## HARDWARE ERRATA REPORT

P/N **PCM-052**

phyCORE-Vybrid System on Module

Revision A1, 5 February 2015

Figure 1: Errata 02 Rework

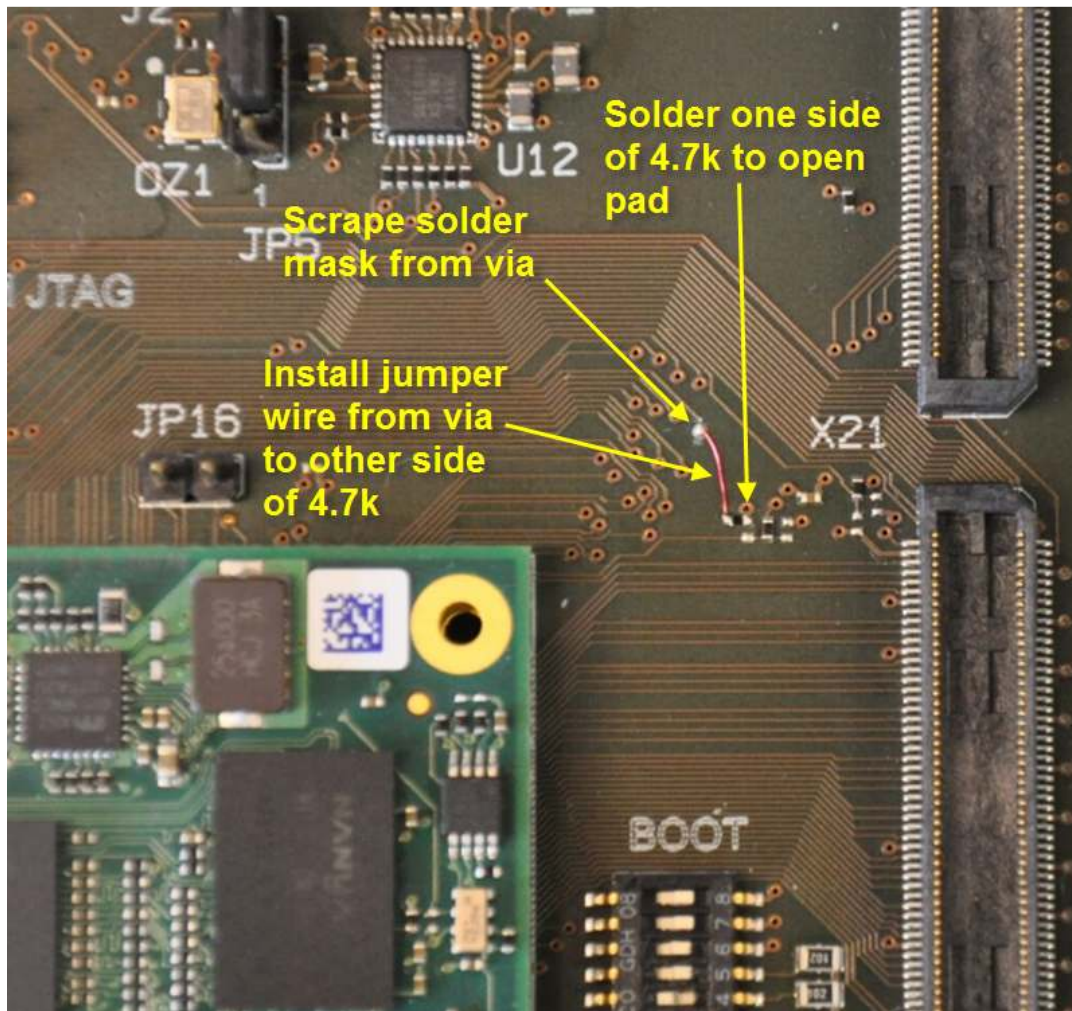
**Errata Description:** The NAND controller's  $\text{NFC\_R}/\overline{\text{B}}$  by default should be high, putting the NAND flash into a ready state. Instead,  $\text{NFC\_R}/\overline{\text{B}}$  signal floats at power on. The system reads this as busy, and therefore, not ready for commands.

**Workaround:** Solder re-work must be done on the phyCORE-Vybrid Carrier Board (PCM-952). Add a 4.7kΩ resistor between  $\text{NFC\_R}/\overline{\text{B}}$  and VDD\_3V3. Figure 1 below, shows a 0402 package 4.7kΩ (1/16 W, 1-5%) resistor soldered to the top pad of R114 (not populated) for a connection to VDD\_3V3, which is then connected by a wire to the  $\text{NFC\_R}/\overline{\text{B}}$  signal available at the respective via.

**Errata Fix:** 1374.1
